SUNDRY NOTICES AND REPORTS ON WELLS

Gissler B #4

This well is in Temporary Abandonment (TA) status. Due to its non-commercial status and no prospect for future use, we request approval to abandon the well as follows:
(see schematics)

PROPOSED P&A
STATUS

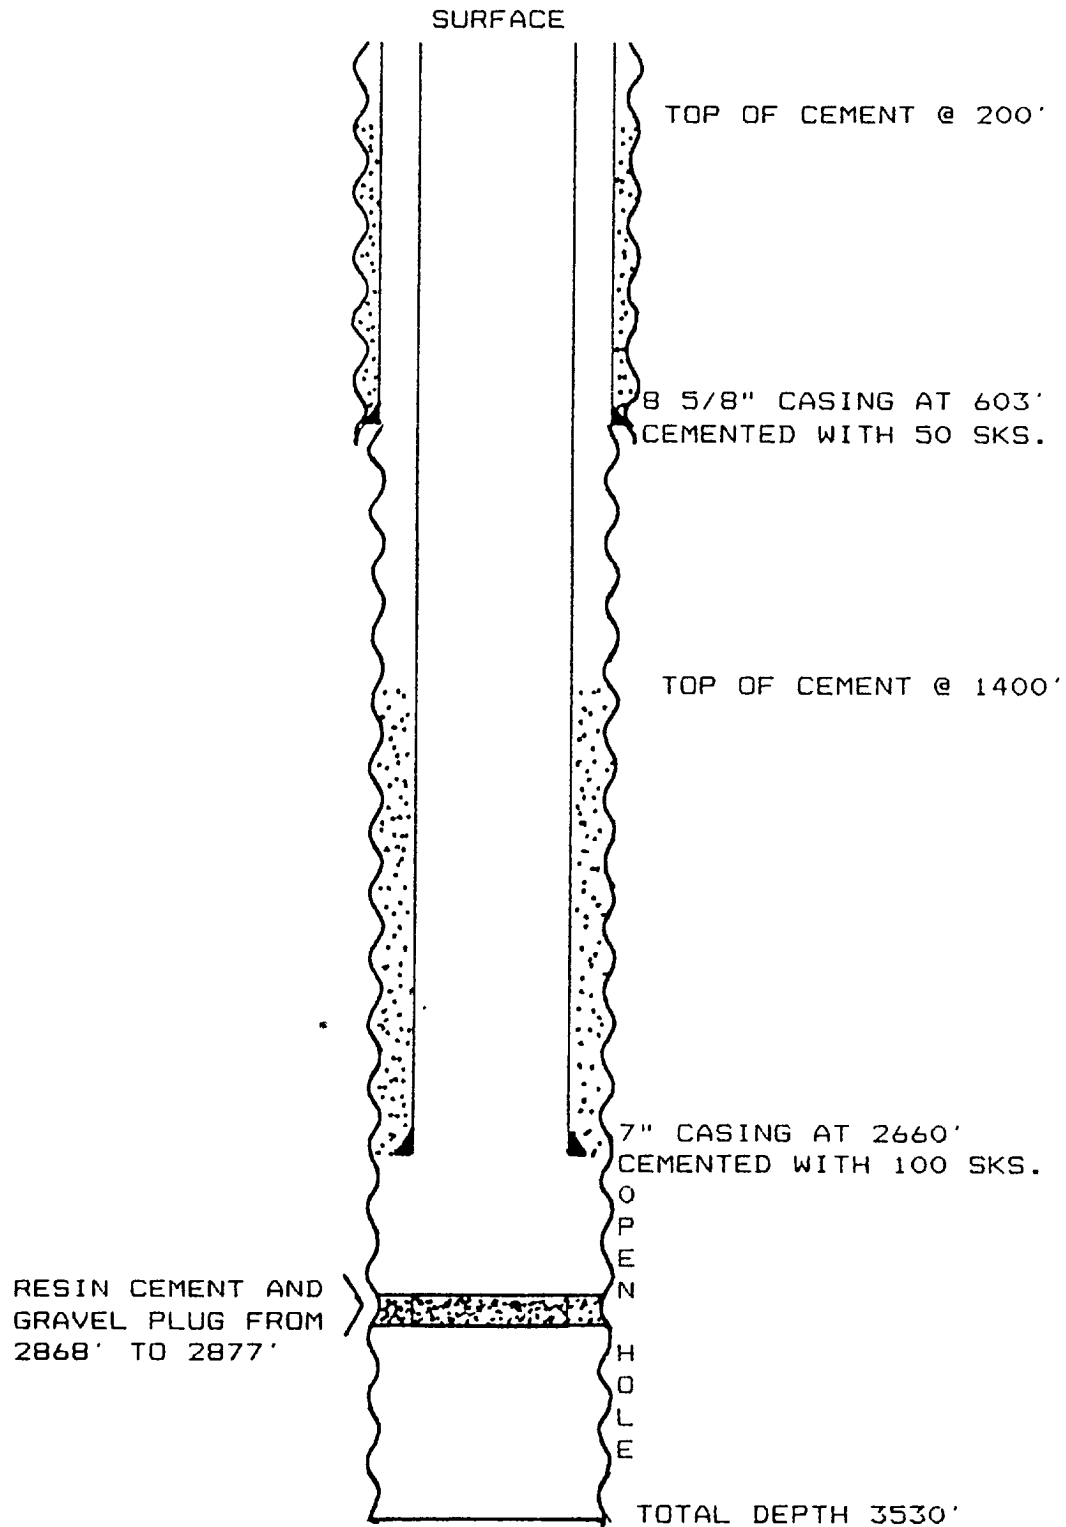
NOTE: All changes & additions as per telecon w/ J.C. McPhaul, 6/11/91.

FILL ANNULAR SPACE BEHIND 8 5/8" CSG.
W/SUFFICIENT CMT TO PROVIDE
COVERAGE FROM 50' TO SURFACE.

PERFORATE @ ~600', establish circulation
to surface, CMT. W/ SUFFICIENT VOLUME
TO CIRCULATE CMT TO SURFACE AS SHOWN

100' CMT PLUG FROM 1350'-1450'

CIBP @ 2600' W/ 35' CMT CAP
